INDESIT company

Model type:
MTA4551NF

Commercial code:
F032574

RE0203T0 Exploded views

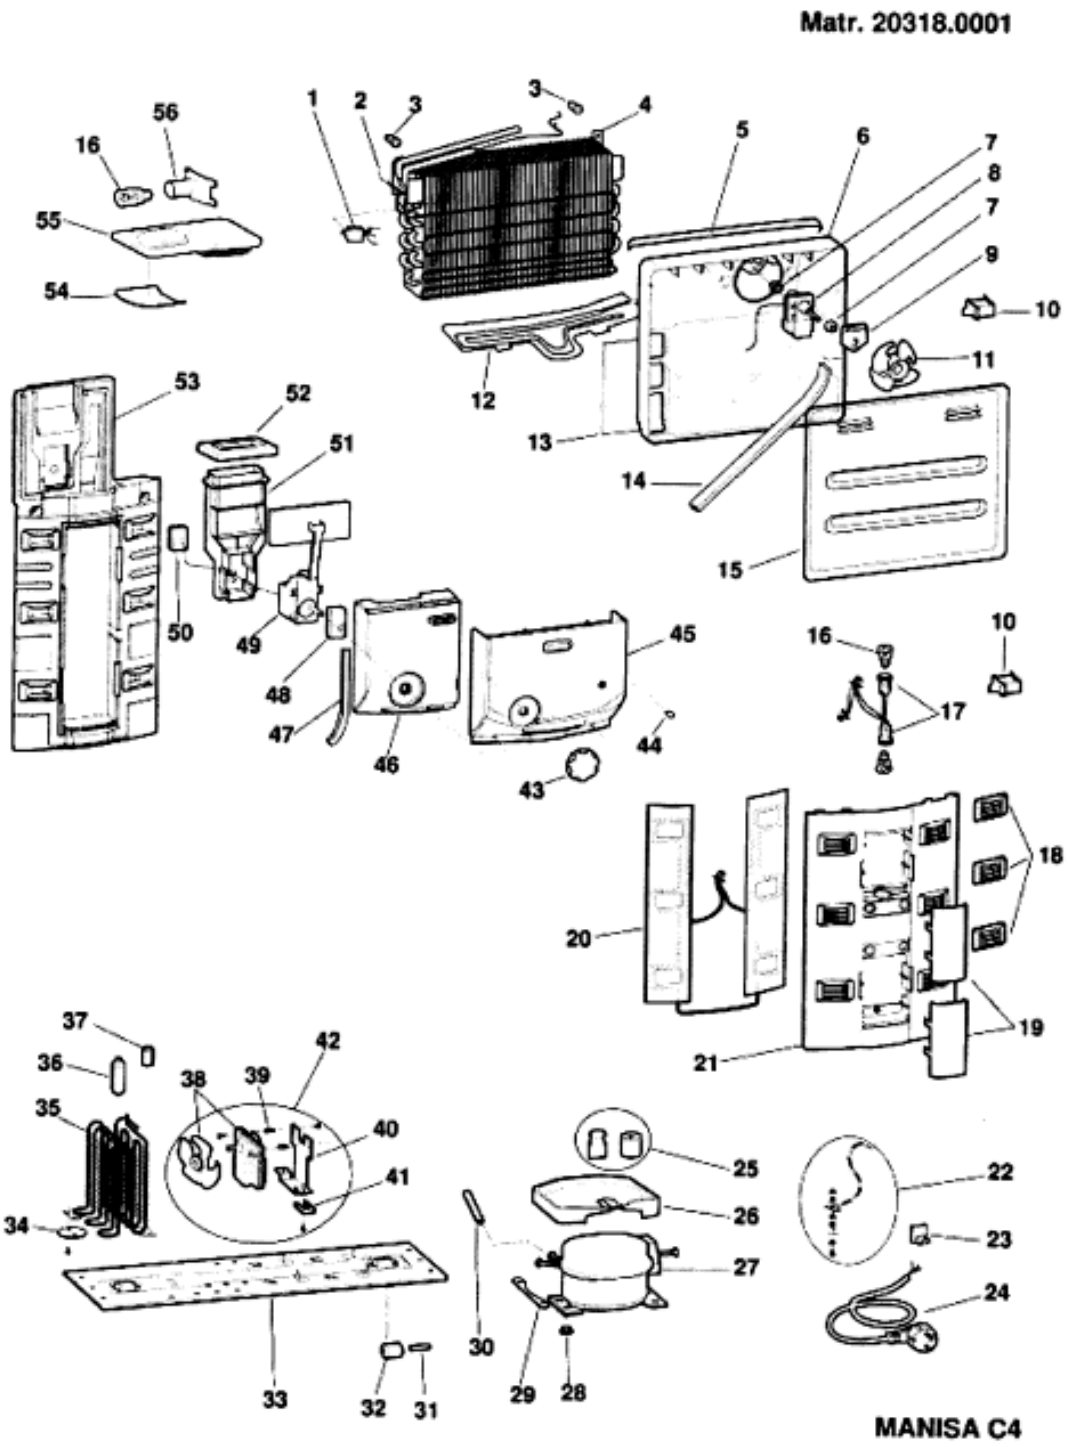
0999333: new double thermofuse

Since 05/05/2003 new double thermofuse will be used on all electronic no-frost models
old codenew code
17497192575

0999360: modification on freezer fan motor

Since 01 July 2004 freezer fan motor has been modified to reduce noise level on no frost models that are produced in Manisa plant. (Old fan motor has grey cover, new fan motor has light green cover.) Spare part code remains the same. If you replace the old fan motor with the new fan motor, rubber for fan has to be replaced with the new one and sponge should not be used with the new fan motor.

0999363: lamp switch has been moved to middle panel of cabinet

Since 10/10/04 lamp switch has been moved from inner side of foamed cabinet to outer middle panel of cabinet on electronic no-frost models which is used R600
114542- lamp switch

0999369: FAN MOTOR MODIFICATION FOR DECREASING NOISE LEVEL

From serial number 50625.0001 on electronic no-frost models and from serial number 50723.0001 on mechanic no-frost models freezer fan motor has been modified for decreasing noise level.

Since RPM of the new motor is lower than the previous one, new fan motor is not interchangeable with the old one, and it cannot be used on the premodified appliances.

0999374: usage of tecumseh evaporating tray

Since 30/09/2005 c00141110 tecumseh evaporating tray HTK12AA will be used on models which has HTK12AA compressor.

Modified parts:
139648 - fan motor
119866 - fin evap cover assembly
140463 - freezer rear cover assembly
140462 - fast feezer cover
140662 - damper styrofoam (eps)
140661 - multiflow upper cover
140663 - multiflow styrofoam (eps)

Premodified parts:
174380 - fan motor
173745 - fin evap cover assembly
174886 - freezer rear cover assembly
174992 - fast freezer cover
174943 - damper styrofoam (eps)
090287 - multiflow upper cover
174944 - multiflow styrofoam (eps)

re0201t0 Exploded views

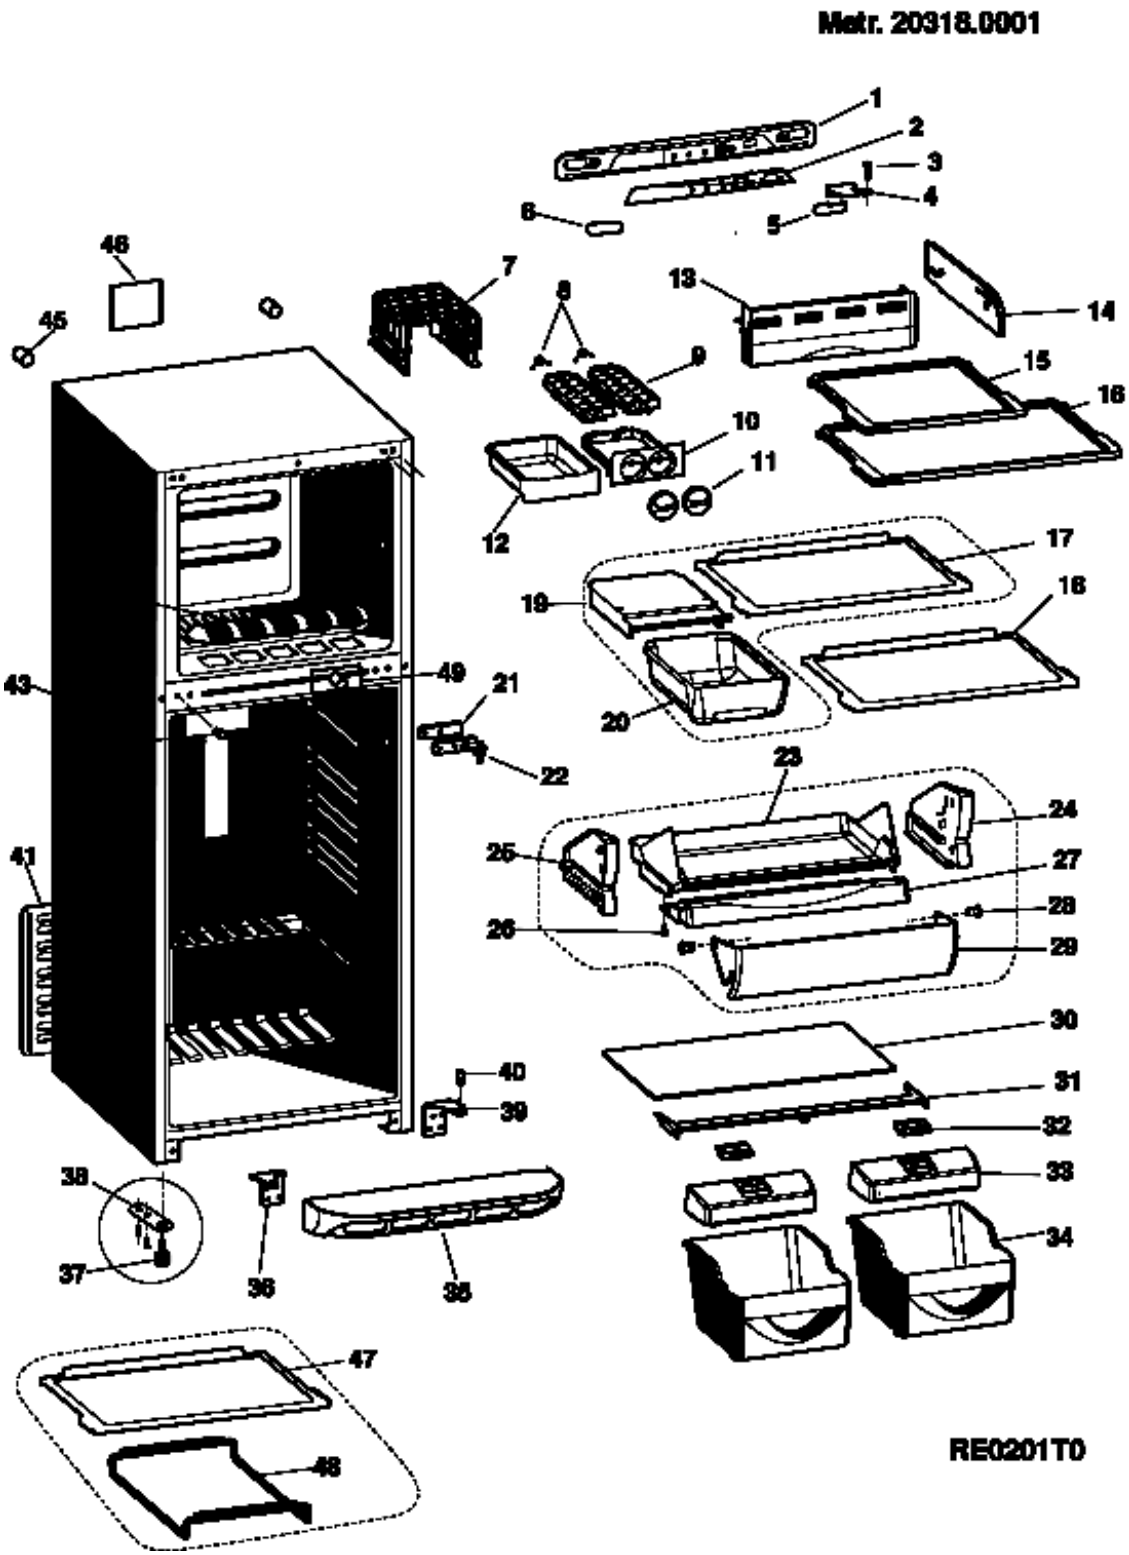
0999368: color modification

Since April 2005, color of products has been changed from Bianco 27 to Polar White in Manisa Plant.

New spare part codes have been given for the below external parts.

Cabinet, cabinet head panel, door, door head panel, door gasket, kick plate.
